# Norwich to Tilbury Deadline 1 Submission

Respondent: Griffin Farms Ltd

Property: NK523970

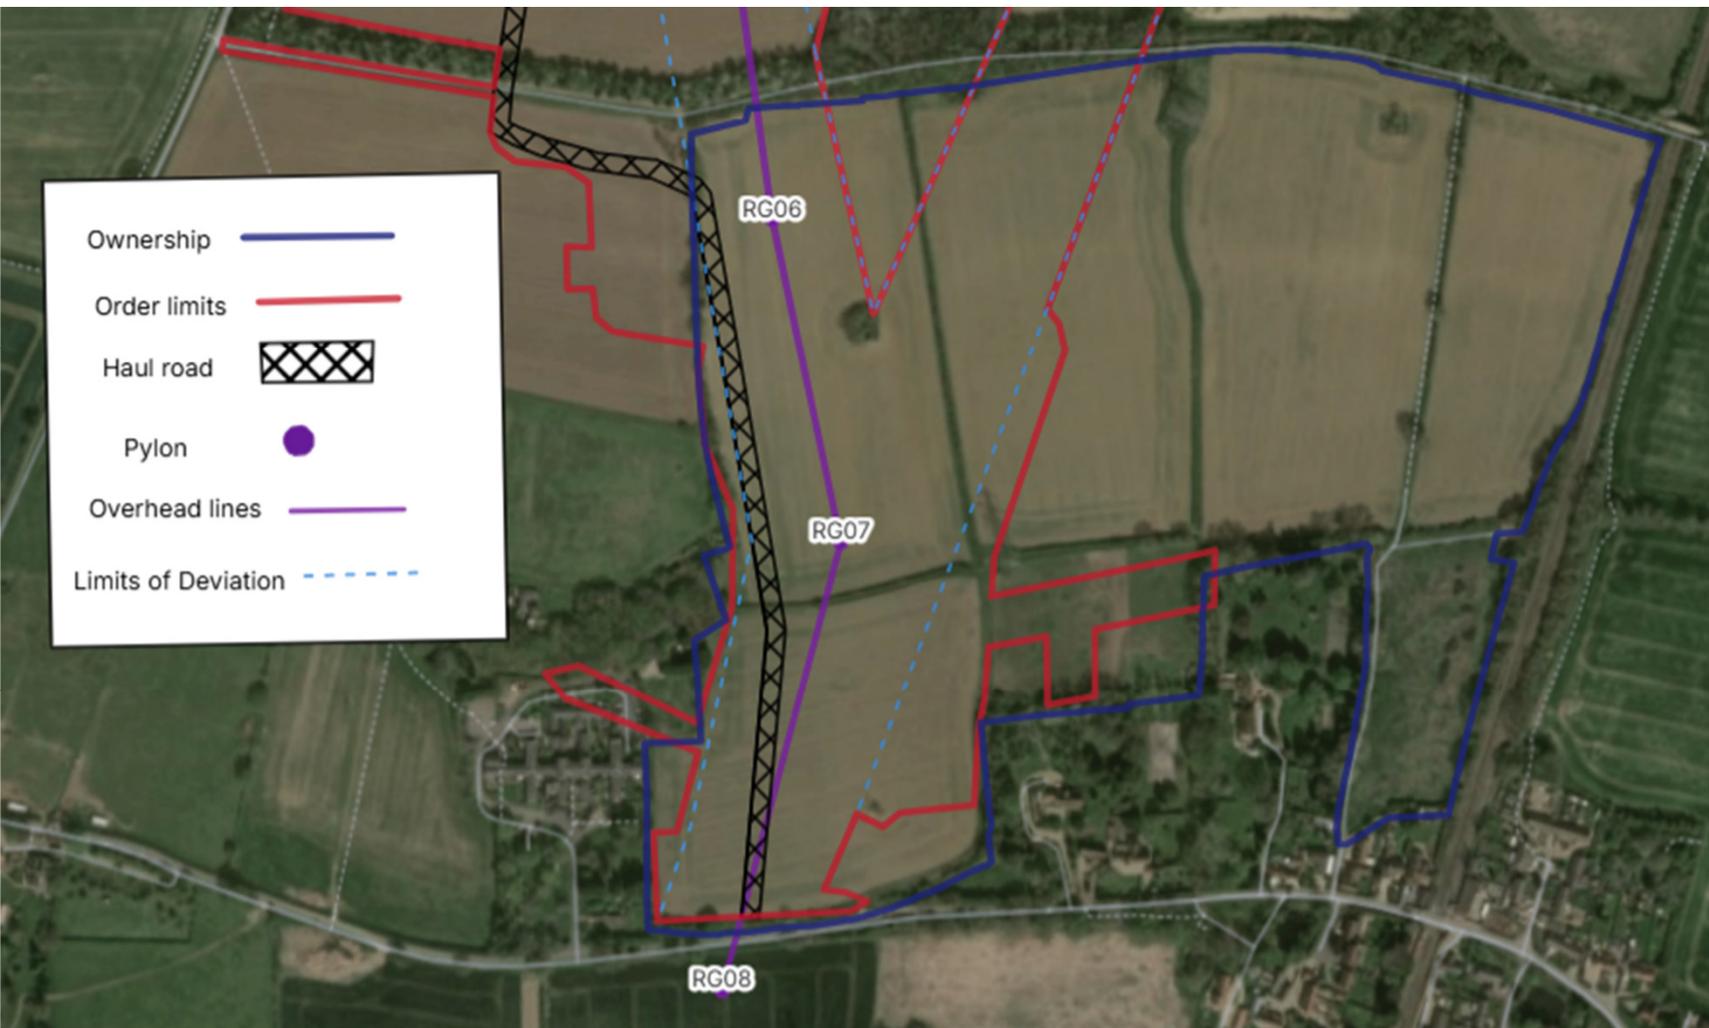
The image above shows the interaction between the Respondents land ownership and the Applicants proposed scheme

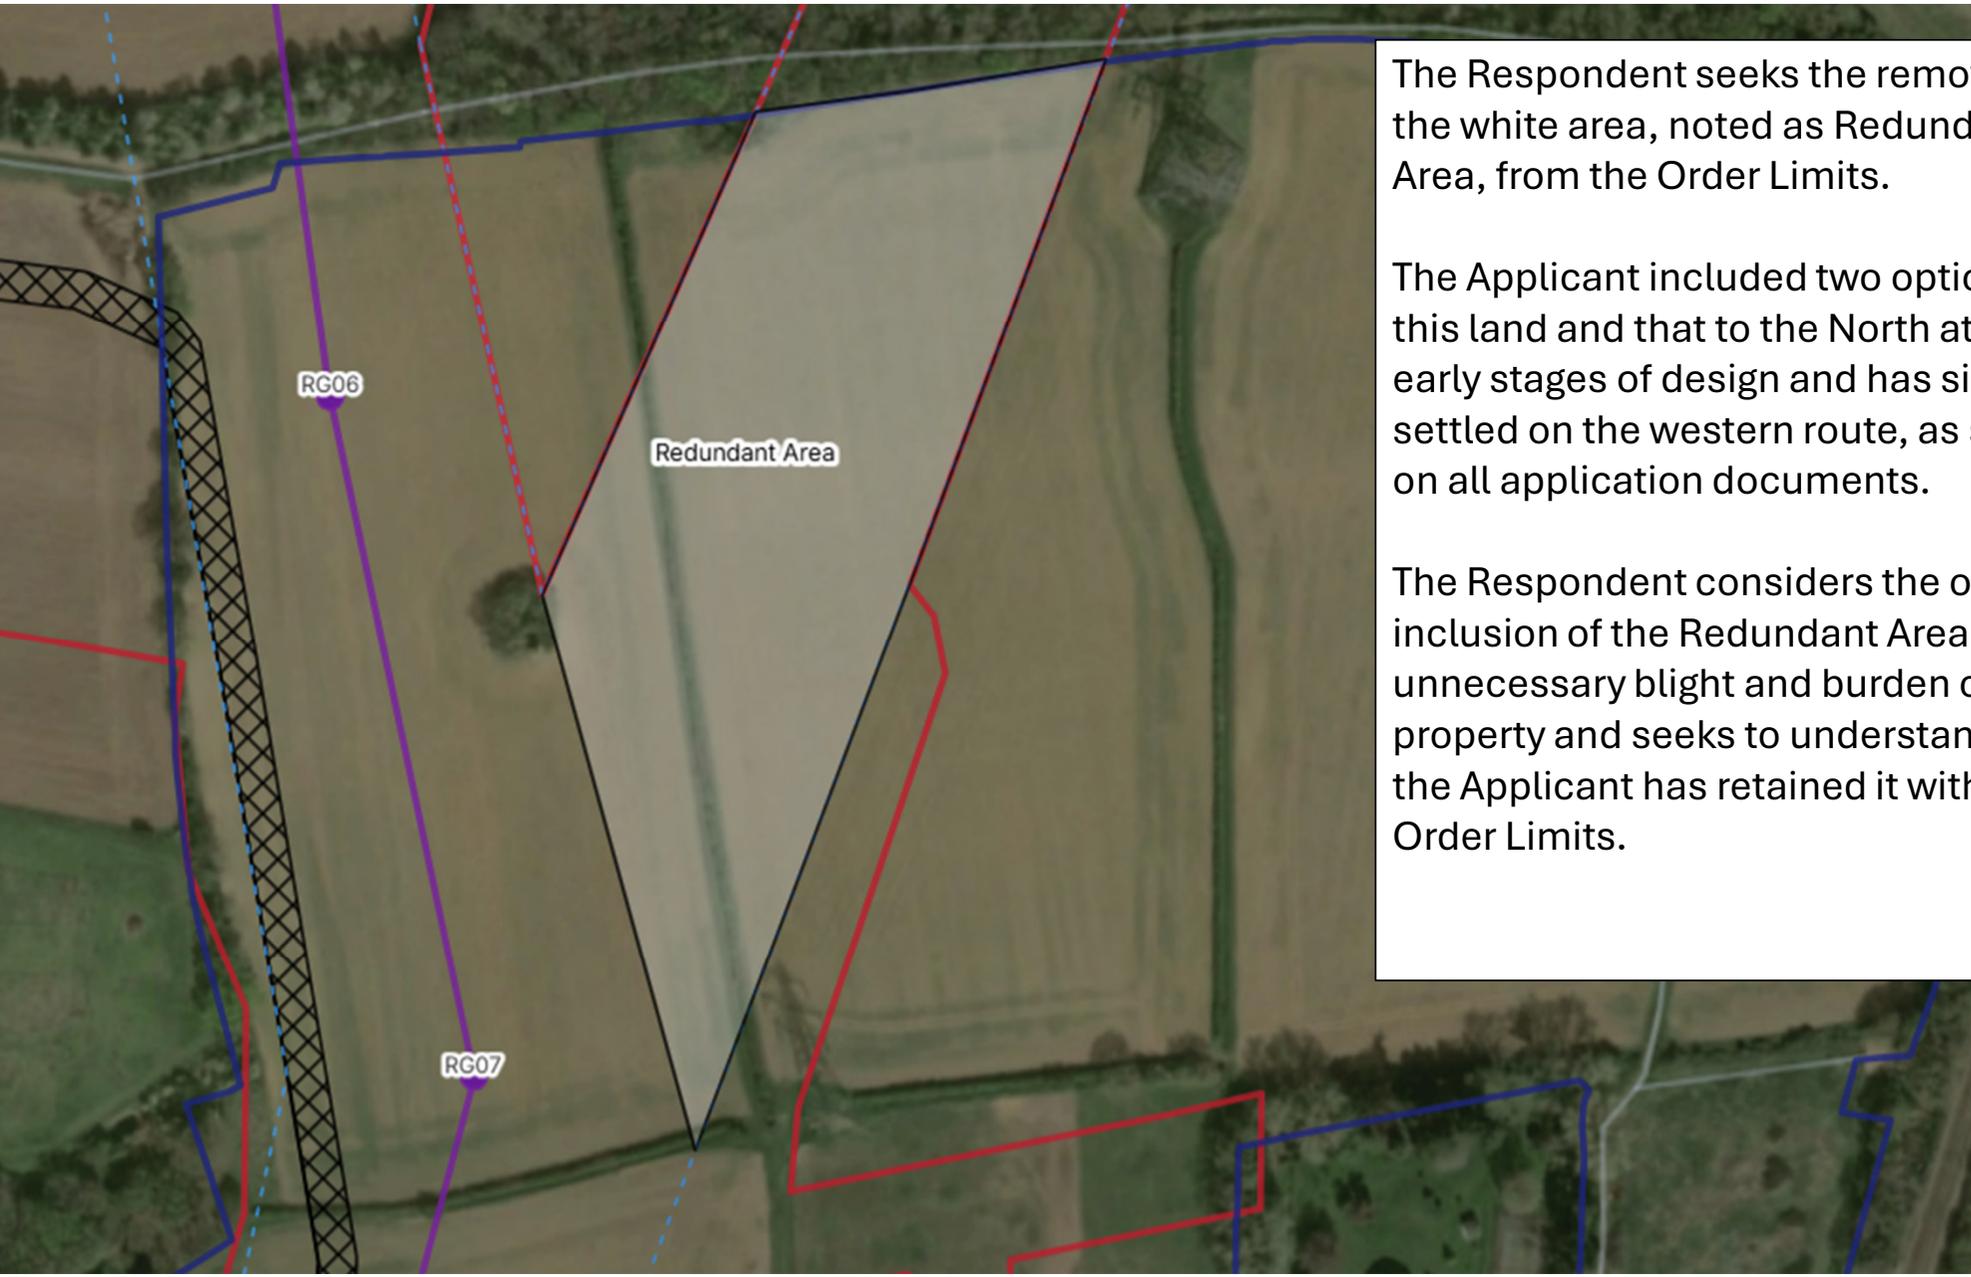
The Respondent seeks the removal of the white area, noted as Redundant Area, from the Order Limits.

The Respondent considers the ongoing inclusion of the Redundant Area to be an unnecessary blight and burden on their property and seeks to understand why the Applicant has retained it within the Order Limits.

The Respondent seeks the repositioning of Pylon RG07 to a location approximately 30m further south, as shown by point GF07.

The position of RG07 will impede future use of the field for agriculture and result in 'dead ground'. Whilst understanding that this is inevitable in some cases, the distance to the field boundary to the south is so modest that it seems unreasonable not to make a better attempt to position the pylon on said boundary.
